Post-Exhibition Report – PP-2022-658

Lourdes Retirement Village - 95-97 Stanhope Road, Killara (provision of a maximum 141 independent living units, residential aged care facility (110 beds) and 63 private dwellings)

Figure 8 – Bushfire Evacuation Risk Maps (source: SEPP (Housing) 2021 (accessed November 2023))

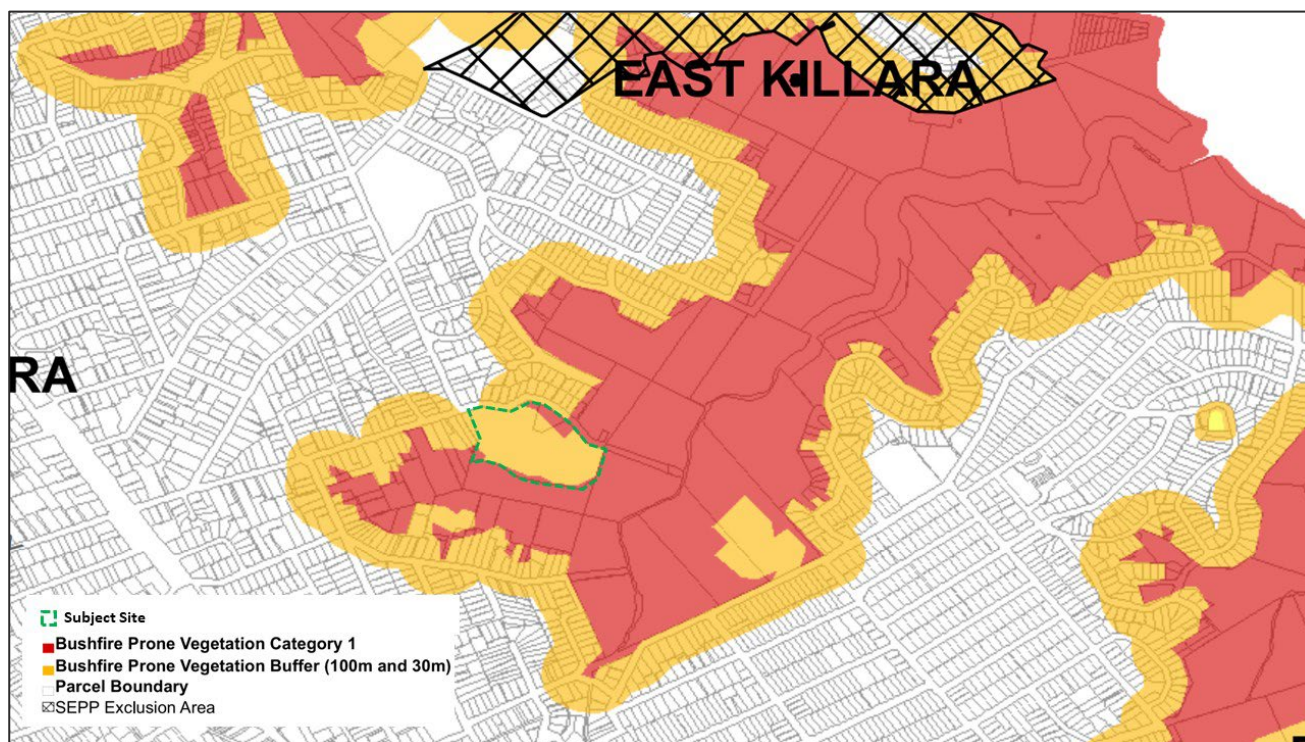
Council has prepared Bushfire Evacuation Risk Maps (**Figure 8**) identifying areas where severe evacuation risks may occur during a bushfire event. The map limits certain developments in these areas, however this does not apply to any part of the site or adjacent areas. Council has also amended its LEP to zone those areas considered an evacuation risk and identified on those maps to E4 Environmental Living (now C4 Environmental Living) to limit future growth.

Figure 9 – Agile Planning team Recommended zones (source: Agile Planning)

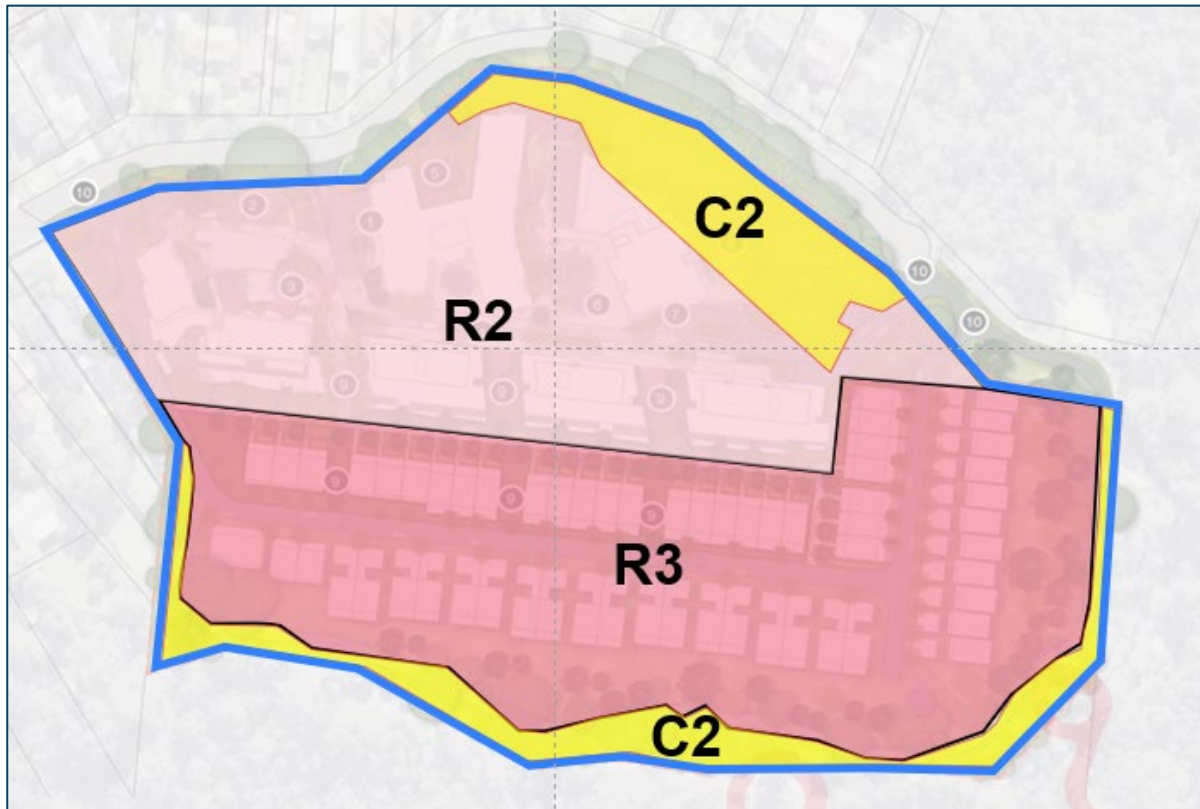
The R3 Medium Density Residential zone in the KLEP 2015 includes several more intensive residential uses (such as multi-dwelling housing and shop top housing). Given community and council concern regarding density and built form outcomes of the site, the Agile Planning team recommends that the top half of the site is maintained as R2 Low Density Residential (see **Figure 9**) to ensure that any future built form is commensurate with what is currently located on site.

The application of the R3 Medium Density Residential zone across the lower portion of the site proposing 'townhouses' is considered appropriate and therefore no further amendments to the zone, outside of the areas to be zoned C2 Environmental Conservation, are recommended for this area (see **Figure 9**).

Figure 10 – Agile Planning team recommended HOB map

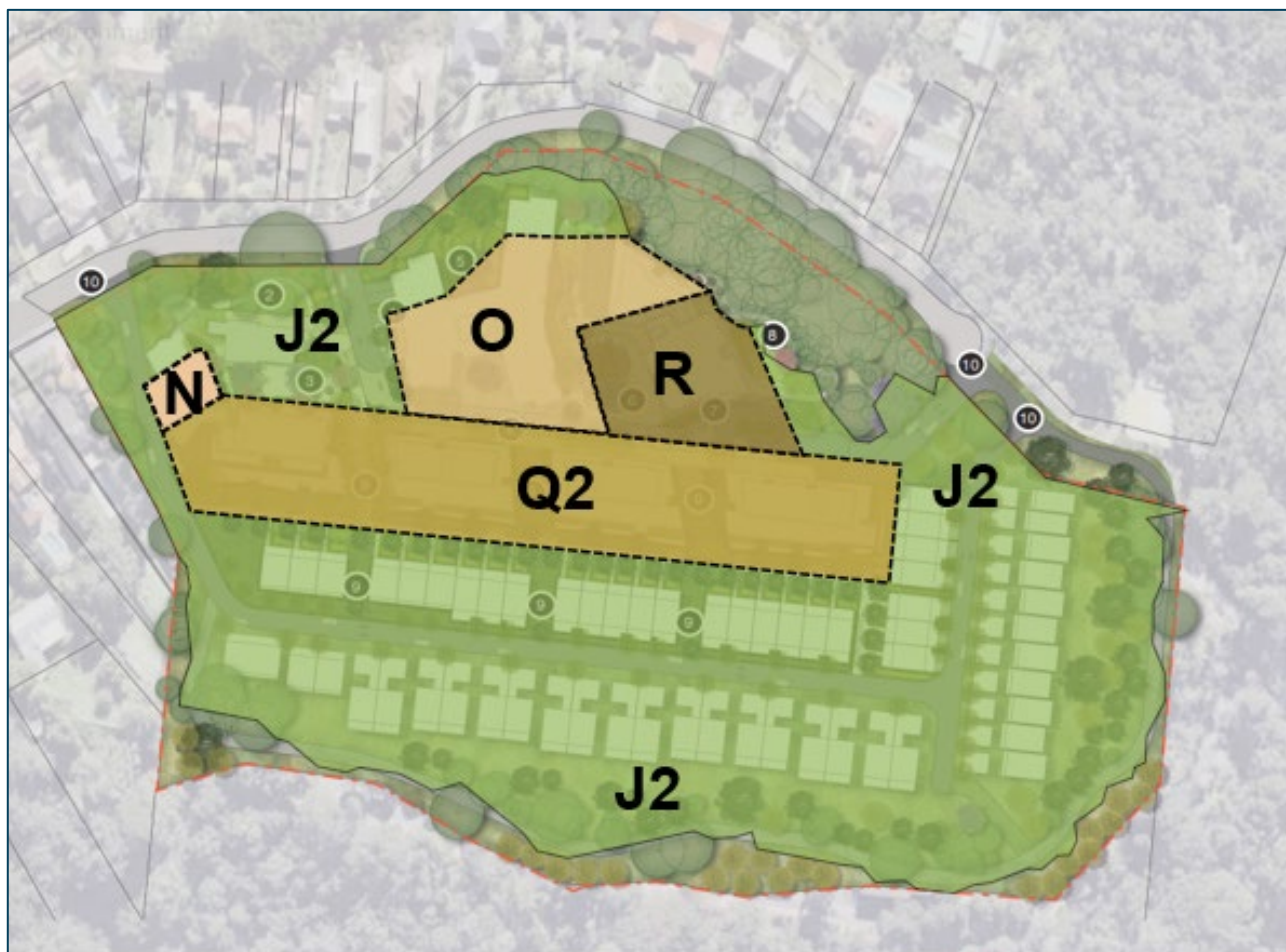
The proposed Height of Building (HOB) map details the proposed heights along Stanhope Road ranging between 11.5m and 16m. The draft DCP includes upper-level setback controls to ensure a suitable transition to the surrounding low density residential areas. The supporting concept plan also

The Agile Planning team has undertaken design testing of the proposed heights and building footprint and prepared alternative scenarios (while working within the proponent proposed FSR of 0.85:1). The testing established that the proposal could still achieve the same yield with reduced heights adjacent to Stanhope Road.

Given the low-density characters of the adjacent residential areas, the Agile Planning team recommends the maximum height of building is reduced to 9.5m in some areas (**Figure 10**) to provide a more appropriate height transition from 2 up to 3 storeys along the visible interfaces of Stanhope Road.

Figure 11: Exhibited and Post Exhibition Proposed FSR maps

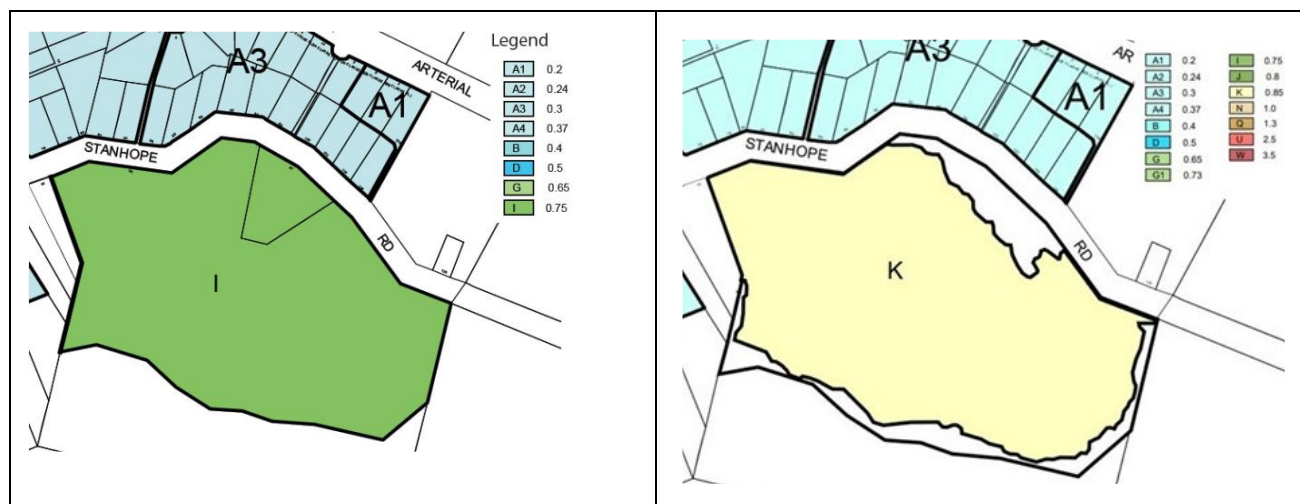
For the subject site, the proposal originally sought an increase in maximum FSR of 0.75:1, based on the ability to develop the whole site. To address the issues raised during public exhibition relating the protection of vegetation, the supporting concept plan was amended to reduce the impacts any future development may have on the site. This included relocating built form to avoid the vegetation areas identified for retention, as well as rezoning parts of the site as C2 Environmental Conservation. This has reduced the developable land zoned for residential purposes from 52,906m² to 45,470m². This is best demonstrated in the image below showing the extent of land to be used for FSR calculations being reduced.

FSR is expressed as the ratio of gross floor area compared with the site area, when an FSR of 0.75:1 is quantified on the site as exhibited (52,906m²) it would result in permitting approximately 39,650m² of GFA. To deliver 38,650m² GFA on the reduced zoned area (45,470m²) the FSR in turn is required to be adjusted to 0.85:1.

The Agile Planning team has confirmed through urban design testing that the proposed FSR (0.85:1) can be achieved on the reduced GFA (38,600m²) without the need to modify the other development standards. The adjustment to FSR is a technical adjustment to reflect the post-exhibition proposed changes in zoning.
